TOWN OF LOS GATOS PLANNING COMMISSION REPORT

DATE: August 19, 2022
TO: Planning Commission
FROM: Joel Paulson, Community Development Director
SUBJECT: Review and Recommendation of the Draft Objective Standards to the Town Council.

TOWN OF LOS GATOS
DRAFT OBJECTIVE STANDARDS
August 24, 2022

Summary of Revisions Made and Responses to Comments Received at the Planning Commission Hearing of June 22, 2022

Figure A.11.1

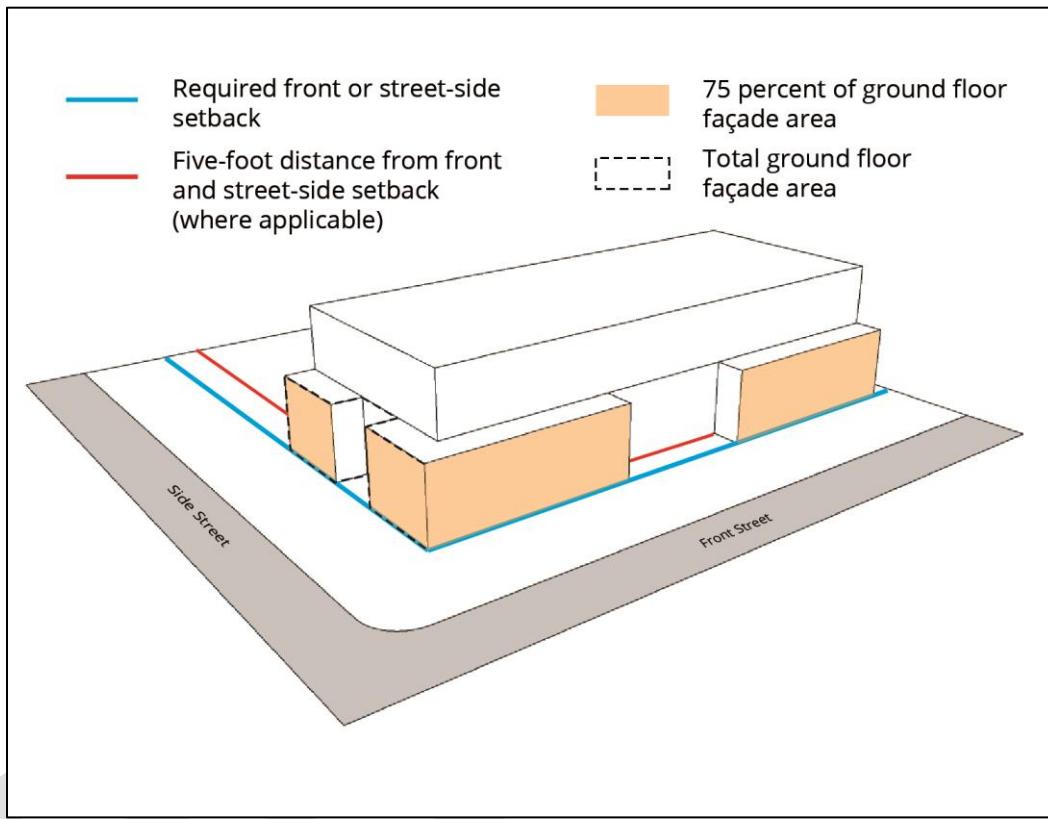
New A.11.1 (Line 41): The Community Design Element of the 2040 General Plan encourages consistent setbacks Town-wide and reduced setbacks in Community Growth Districts (CGD). For this reason, Standard A.11.1 was written to be specific to CGDs. Given the policies in the Community Design Element and the comments made by the Planning Commission during discussion of this item, staff requests direction on whether this standard should apply Town-wide or only within CGDs.

41			Why does this only include Community Growth Districts (CGDs)?	<p>Likes that it only applies to Community Growth Districts otherwise it could make them look out of place. It might also limit design related to arcade setback standards in Section B.</p> <p>Can we apply this just to mixed-use? It should apply to ground-floor commercial.</p> <p>Big focus during GP discussions was street-activation and should be kept in mind during revisions.</p> <p>The following policies discussing setbacks are included in the Community Design Element of the 2040 General Plan:</p> <p>CD-2.10 (Town-wide): Well-Defined Street Fronts - Require new buildings to maintain a consistent setback from the public right-of-way in order to create a well-defined streetscape. Require new buildings throughout Town to use consistent setbacks.</p> <p>CD-7.1 (All CGDs): Neighborhood-Friendly Design - Encourage buildings and sites within all Community Growth Districts regardless of designation, including shopping centers undergoing redevelopment, to integrate design features that create a pedestrian- and neighborhood-friendly environment, such as by siting buildings close to the sidewalks, providing space for small plazas, and including public art.</p> <p>CD-9.1: (LGB CGD): Setbacks and Step Backs of Massing - Require medium density, high density, and mixed-use parcels in the Los Gatos Boulevard District adjacent to single-family parcels to include increased site setbacks and multi-story step backs to minimize the impact and increase compatibility with smaller adjacent structures.</p> <p>CDP-11.7: (Lark CGD): Reduced Setbacks - Allow reduced setbacks to foster a more urban environment focused on corporate centers, commercial shopping areas, medical services, and hospitality uses.</p> <p>Consistent setbacks are encouraged by CD-2.10, while reduced setbacks are encouraged in CGDs. For this reason, Standard A.11.1 was written specific to CGDs. Given the above policies and the comments made by the Commission during discussion of this item, staff requests direction on whether this standard should apply Town-wide or only within CGDs. The corresponding figure/diagram will be updated accordingly.</p>

Figure B.4.1f

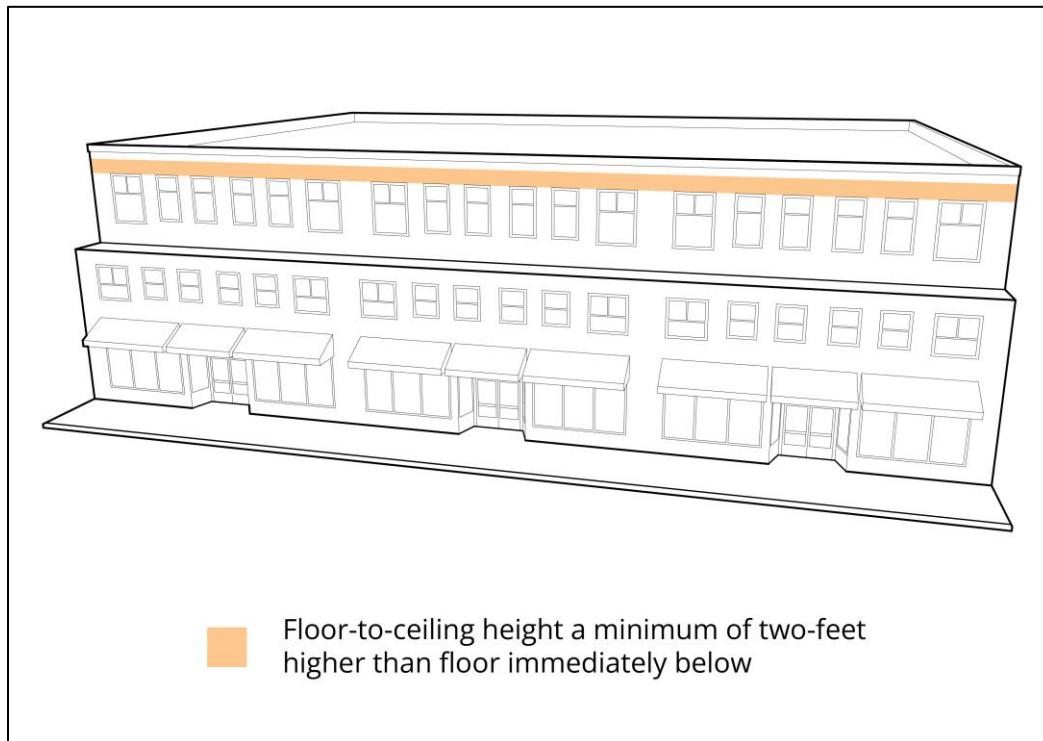
48	B.3.1.c	B.3.1.c	Staff addition/revision.	Revised the change in façade or roof height from four feet to two feet to align with the height limitations of the Town Code.
49	B.3.4	B.3.4	Staff addition/revision.	Deleted to eliminate potential conflict with architectural styles.
50	B.4.1	B.4.1	Example pictures would be helpful.	Photographic examples of the concepts have the potential to communicate unintended values or design guidance. Diagrams have been updated throughout the document to better illustrate the concepts in a more realistic style. Staff does not recommend the use of photos in the document.
51	B.4.1.a	B.4.1.a	Staff addition/revision.	Revised the minimum percent from 70 to 60 percent following case study of buildings with similar heights to those allowed in the Town.
52	B.4.1	B.4.1	Why not include varied plate heights in this section? It would make for dynamic architecture.	Added B.4.1.f, offering a solution that the upper floor utilize a higher floor-to-ceiling height that is a minimum of two feet greater than the floor-to-ceiling height of the floor immediately below. New figure B.2.1.f added.
